AB Apparels Ltd

9th November, 2016

Observations

High Stressed Columns in Building.

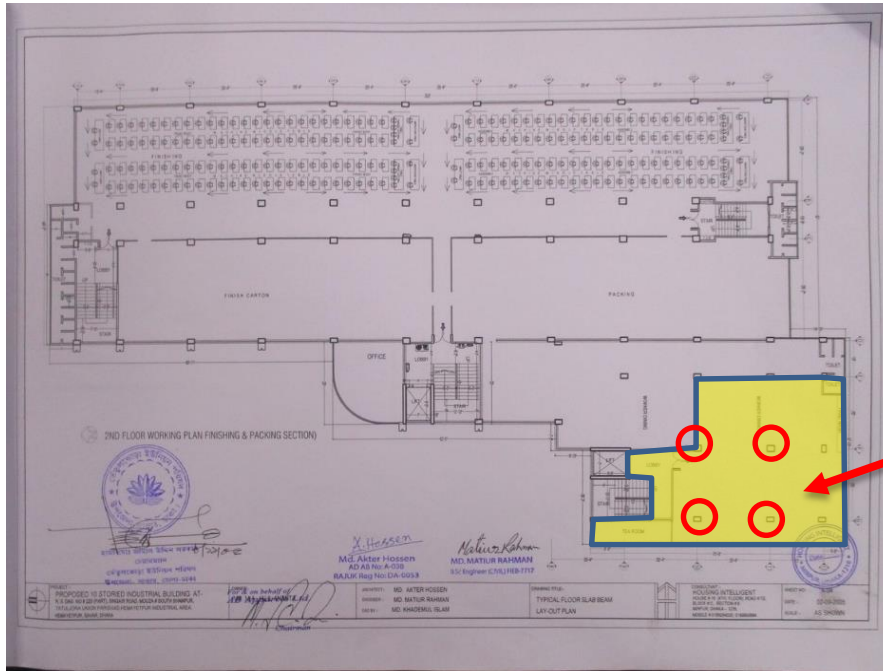
Based on the load
rundown analysis with
the agreed minimum
design live load
assignment, the column
at the circled area has
been found to possess
very low factor of safety
with respect to its load
carrying capacity, giving
a firm AMBER warning.

High Stressed Columns in Building.

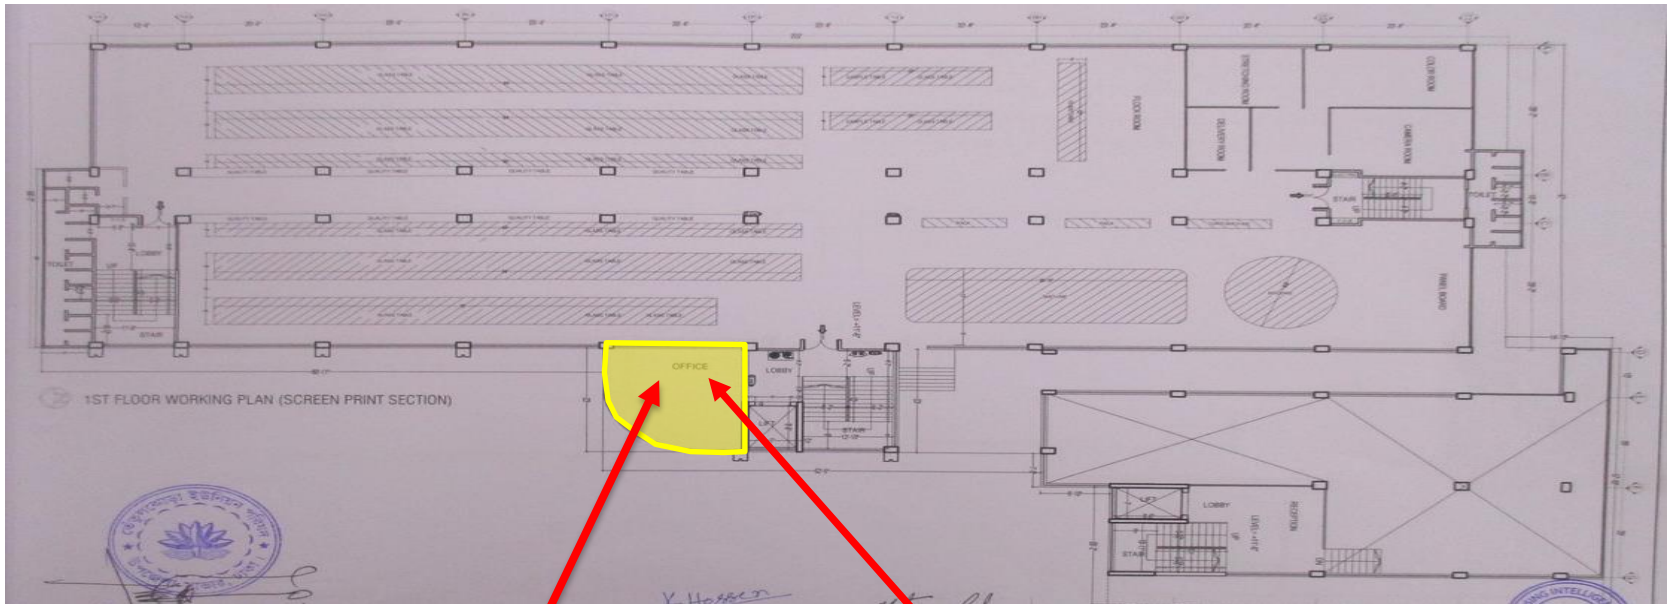
Build up found on the highlighted area of 2nd Floor. High Stack of finished goods have been observed.

Based on analysis by considering live loads according to load plan and build up loads, highlighted column stresses are found below normal design limit.

Localized areas of High Loading

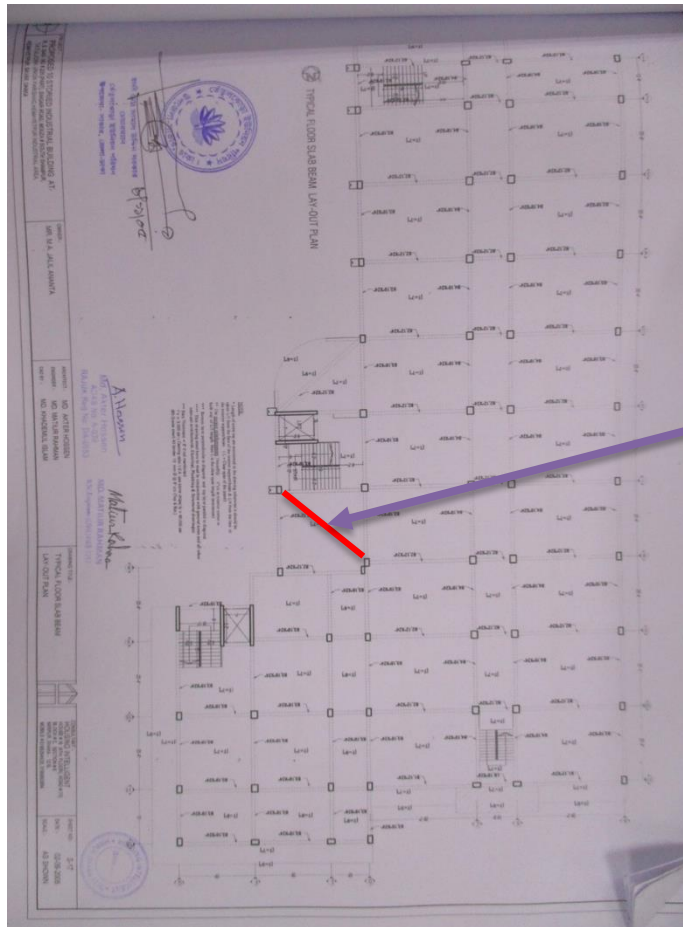
High Stack of Fabric Roll has been observed on 1st Floor.

High Stack of finished goods observed on 6th Floor.

6	Localized area of high loading	Produce and actively manage a loading plan for all floor plates within the factory giving consideration to floor capacity and column capacity.	6-weeks
7	Localized area of high loading	Continue to implement load plan.	6-months

Inconsistencies between permit drawings and as-built structures

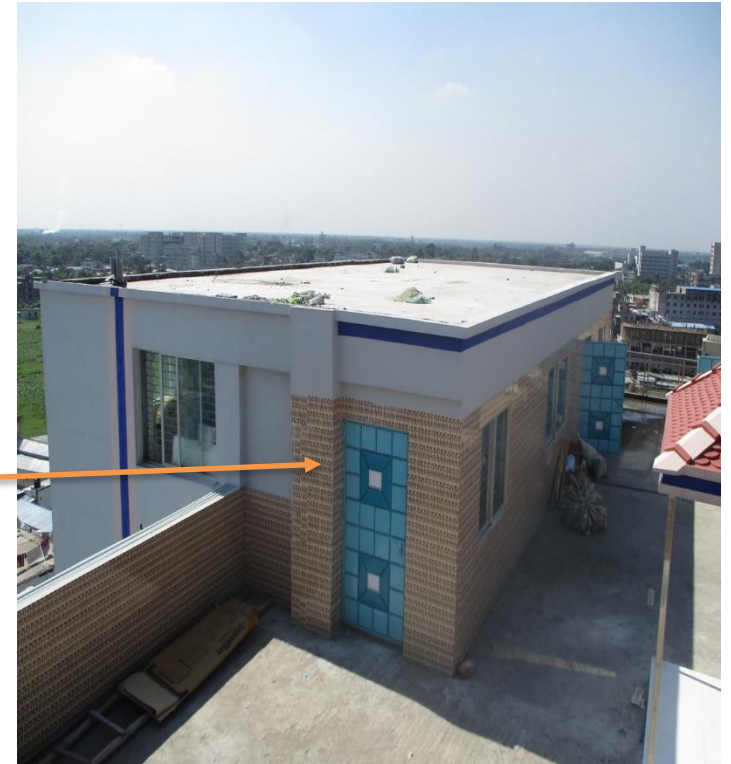
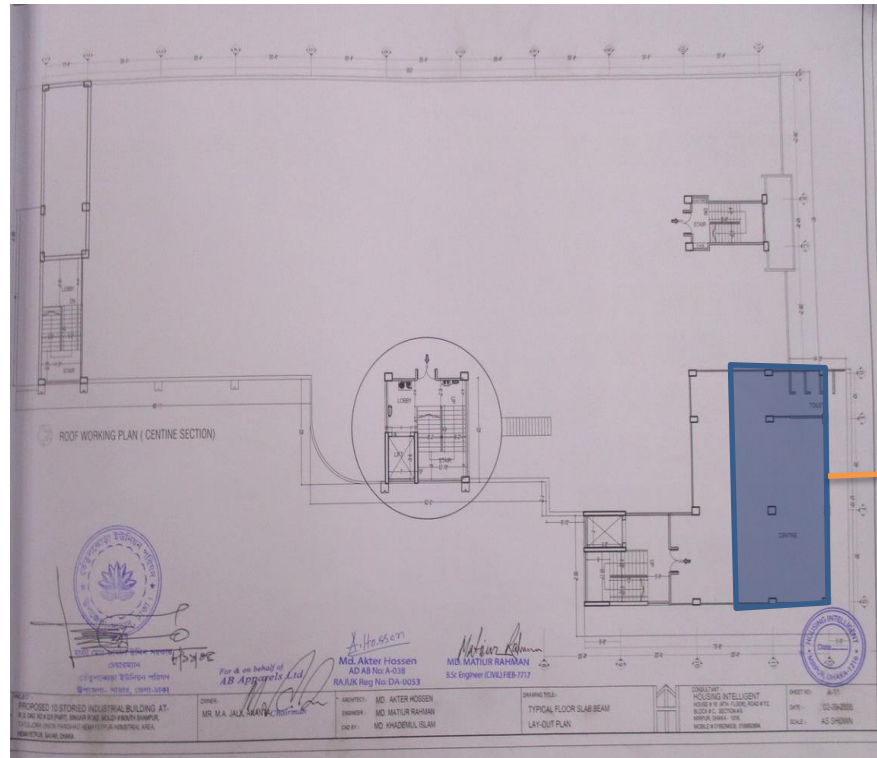
A inclined beam was found on 3rd Floor level which was not mentioned on beam layout

Item No.	Observation	Recommended Action Plan	Recommended Timeline
8	Inconsistencies between permit drawings and as-built structures	As part of the DEA comprehensive As-Built drawings are to be produced.	6-weeks
9	Hairline cracks on beam	Sections of plaster finish to beams and slab to be removed to investigate if cracks penetrate the building structure.	6-weeks
10	Hairline cracks on beam	As part of the Detail Engineering Assessment (see Item 1), Building Engineer to carry out design check on beams and slab taking into account the effect of the cracks on the structure	6-weeks
11	Hairline cracks on beam	Carry out any structural remedial works to cracks as required following assessment.	6-months
12	Exposed Bar on roof	provide proper rust proof material.	6-weeks
13	No Edge protection system	Provide proper edge protection on roof.	6-weeks
